Q&A

VIQRC 2023-2024: Full Volume

Tagged: G5

Figure A:

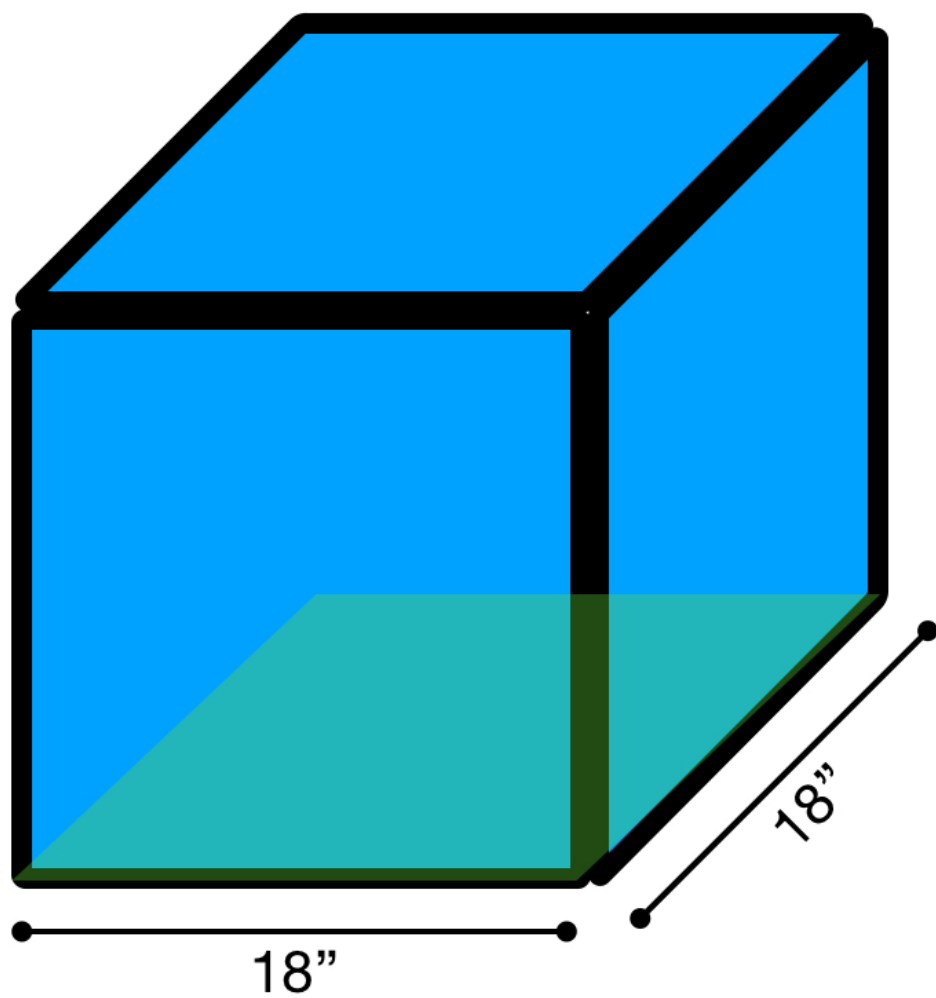
I have included two figures below of different interpretations. Figure A is for reference; it represents an 18"x18"x18" Robot on the Floor. Figure B depicts a Robot vertically rotated 45°, measured relative to the base of the Robot. Figure C also depicts a Robot vertically rotated 45°, but it is still measured relative to the Floor, putting it an illegal 25.5" length. Would Figure B or C be the correct interpretation?
